## PCLS Lakewood Interim Library Prefabricated Building

### DESIGN INTENT SET – ADDENDUM NUMBER 3

ISSUED: January 10, 2023

**AS000**

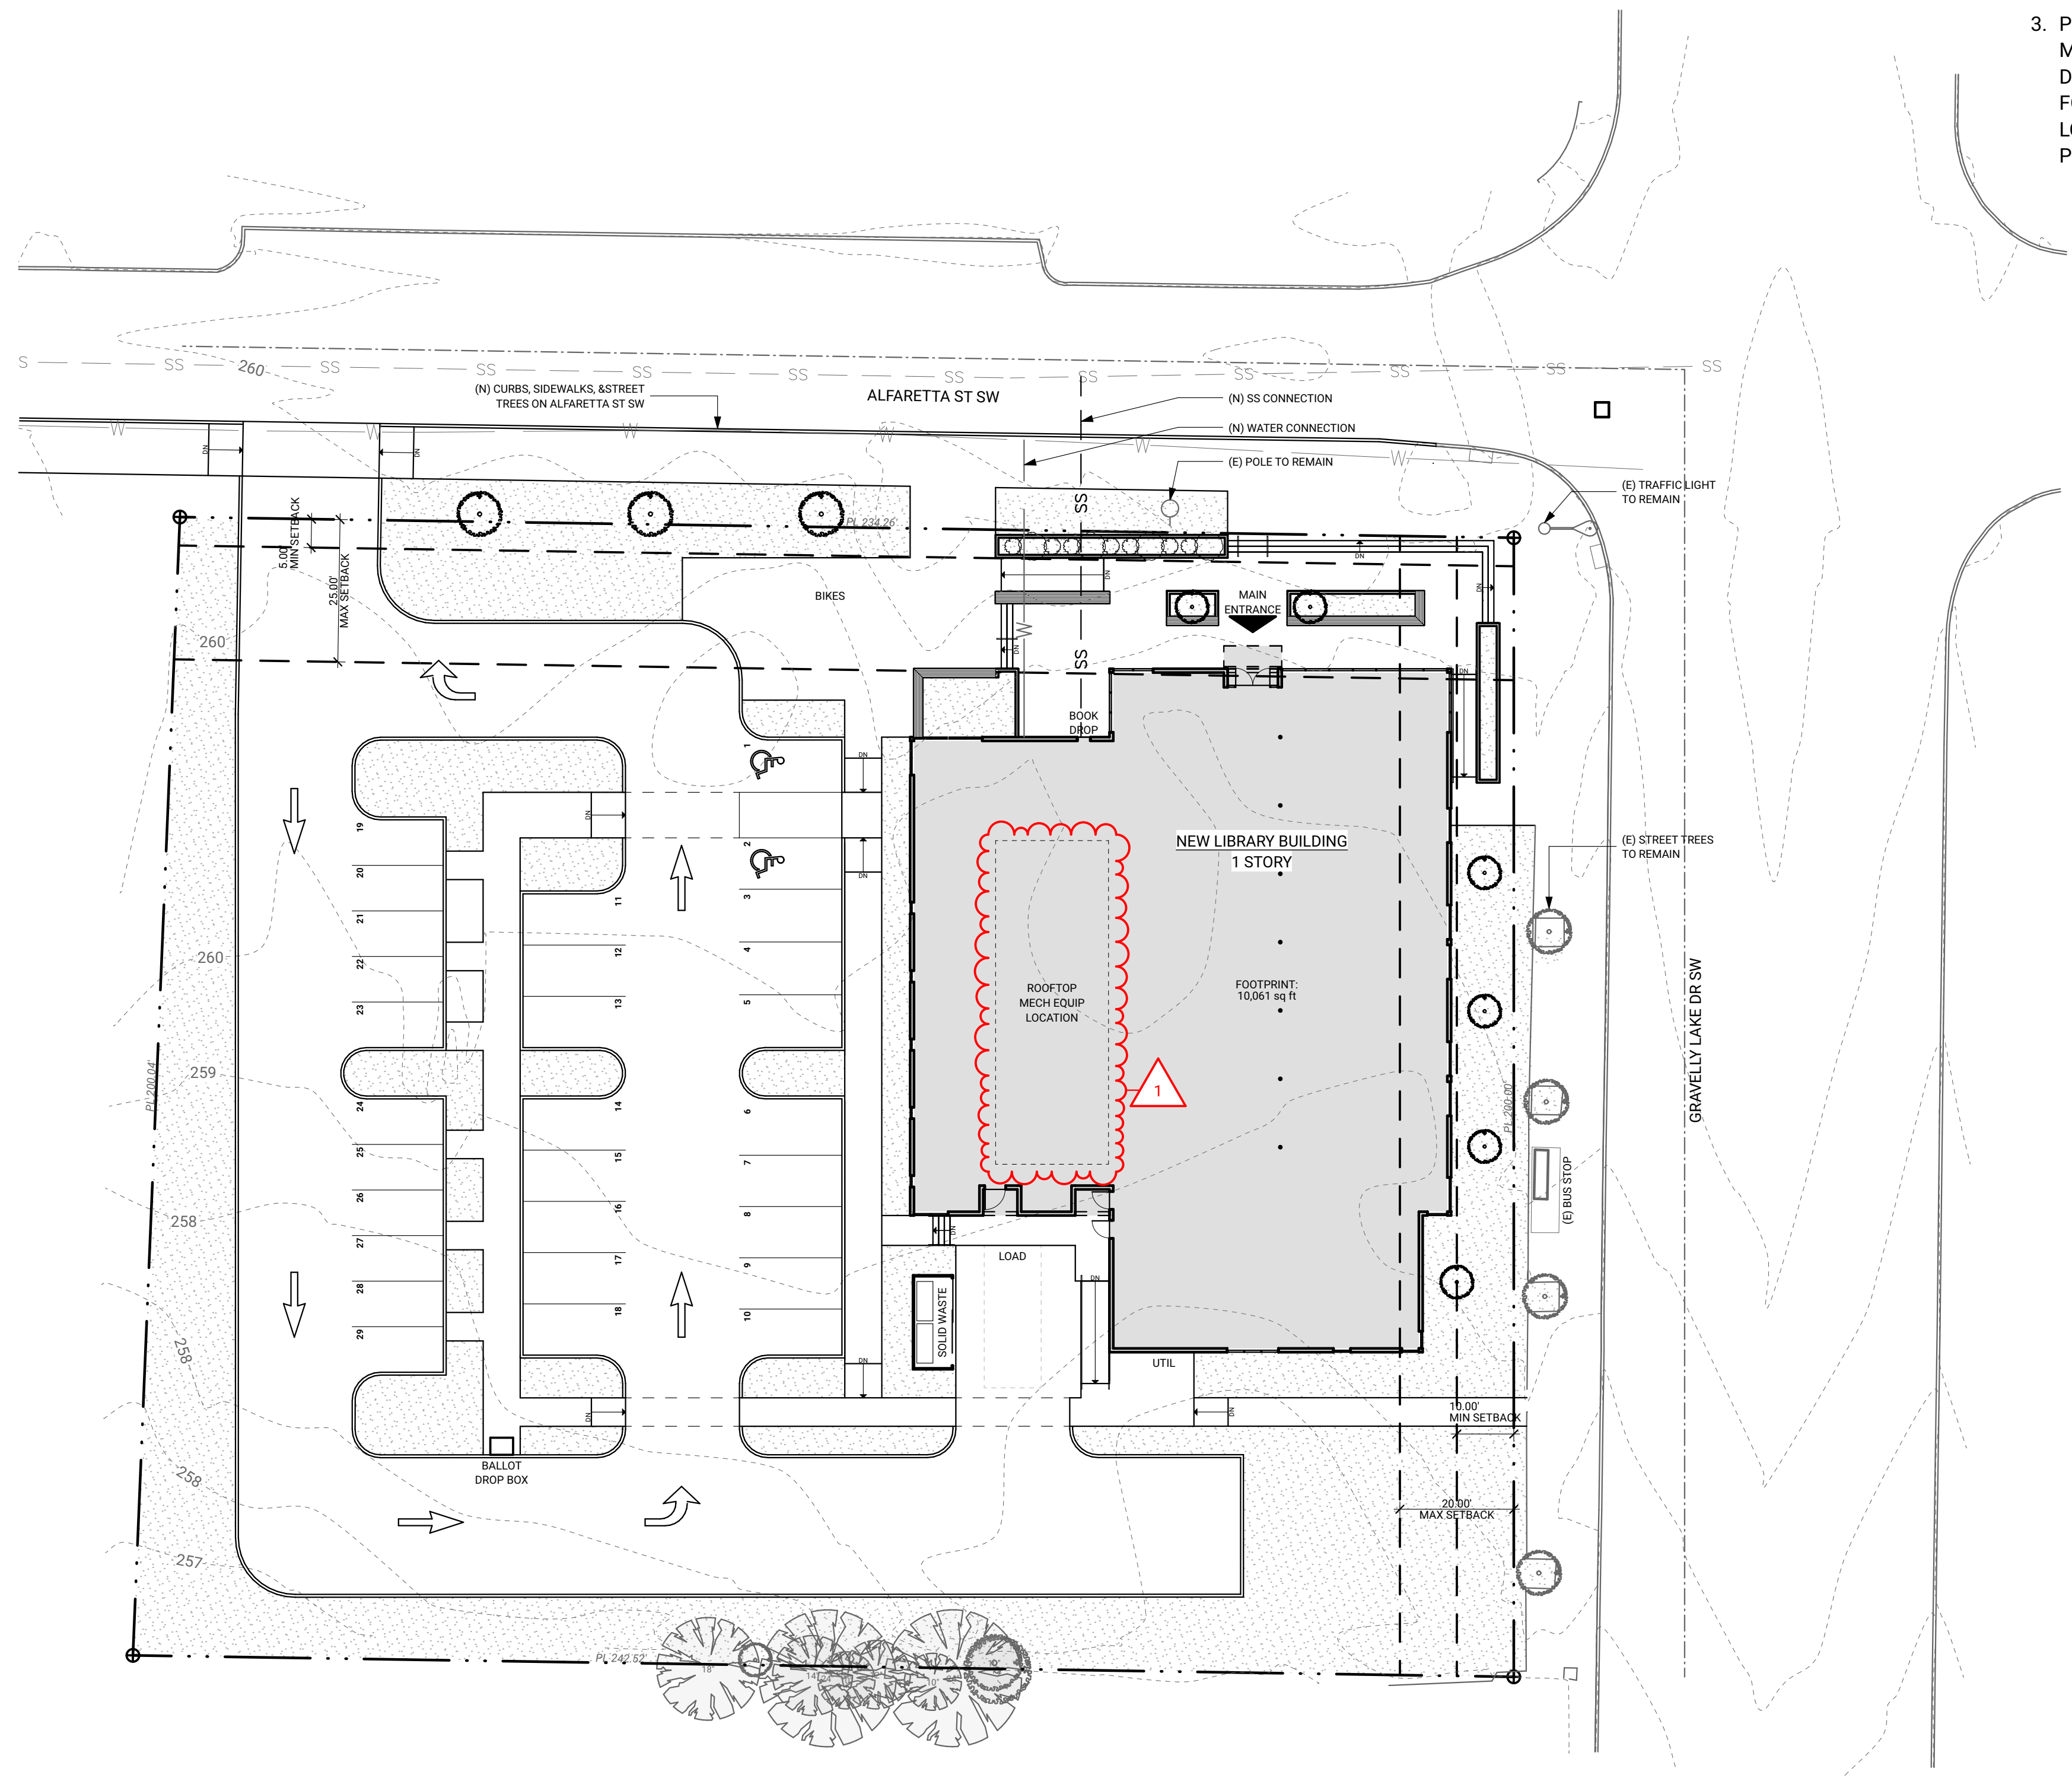
- 1 **Sheet AS000**  
**Clarification:** Area of roof mechanical equipment revised to match mechanical drawings.
- 2 **Sheet A102**  
**Clarification:** Area of roof mechanical equipment revised to match mechanical drawings.
- 3 **Project Manual 000300**  
**Revision:** Bidding period extended by 1 week. Schedule revised as follows:
